✓ Work Order ID 92886

Item Name: Crosstube Mid Fwd, Blue

| DRAWING NO. D206-667-147 | TITLE CROSSTUBE ASS'Y (206L MID FWD) | REV. A | DART AEROSPACE LTD ENGINEERING ORDER | | D.E.O. NO. D206-667-147-A-1 | SHEET NO. SHEET 1 OF 1 | SCALE NTS |

| MFG. APPR. | N/A | DSI 9565 | SHEET 1 OF 1 |

DETAIL P
BONDING STRAP INSTALLATION 2 PL

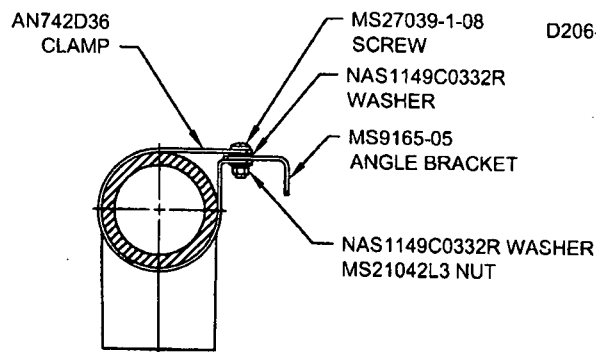
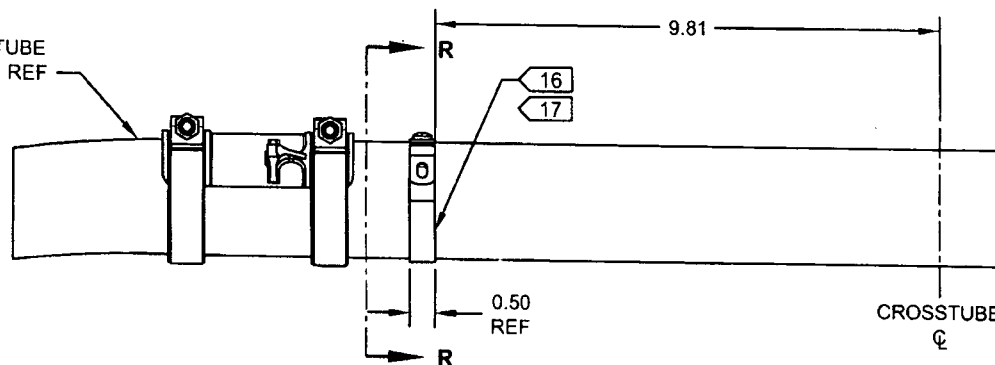
ADD ELECTRICAL GROUNDING STRAP

- 16) MASK AREA UNDER CLAMP PRIOR TO PAINTING
- 17) SEAL EDGES WHERE AN742D36 CLAMP MEETS WITH THE CROSSTUBE USING SIKAFLEX-241/-291 OR MIL-S-8802 CLASS B2 OR PROSEAL 890 SEALANT
- 18) PERFORM RESISTANCE CHECK TO ENSURE MAX RESISTANCE IS 10 MILLIOHMS
